Lifetime Extension EIA

NPP SOUTH UKRAINE LIFETIME-EXTENSION ENVIRONMENTAL IMPACT ASSESSMENT

Expert Statement

REPORT REP-0774

Figure 2: Status of implementation of new and revised RL in Ukraine

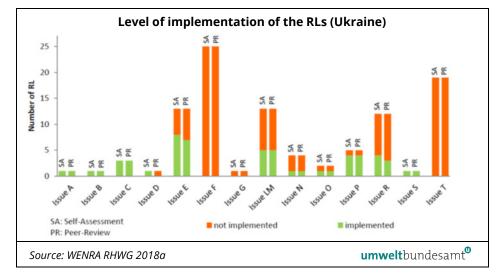
(March 2016). It illustrates that Ukraine has not implemented the new RL F and T in the regulations at that time.

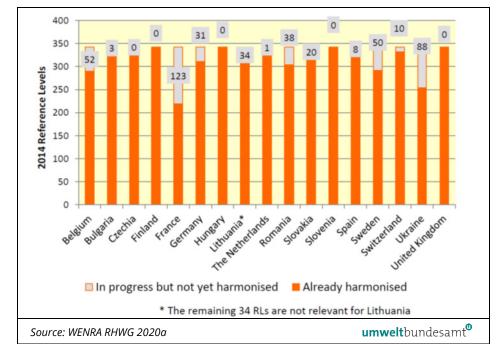
> Ukraine proposed the full implementation of the remaining 74 RLs into the national regulation until March 2018. However, as of 1 January 2019 Ukraine has not implemented 88 RL out of 342, see *Figure 3*. (WENRA RHWG 2020a)

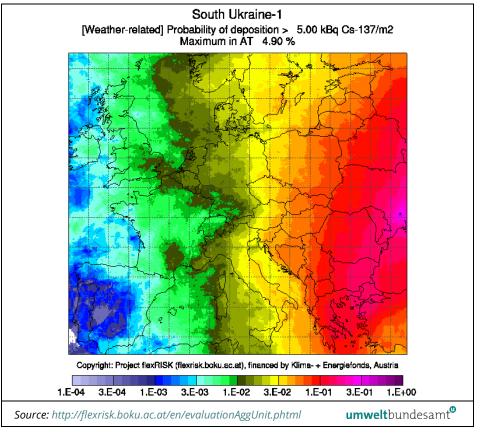
A contamination of 5 kBq Cs-137/m² as shown in Figure 5 is much higher than the level for the Cs-137 contamination in the above table, therefore agricultural countermeasures could be necessary on Austrian territory in case of a severe accident at the South Ukraine site.
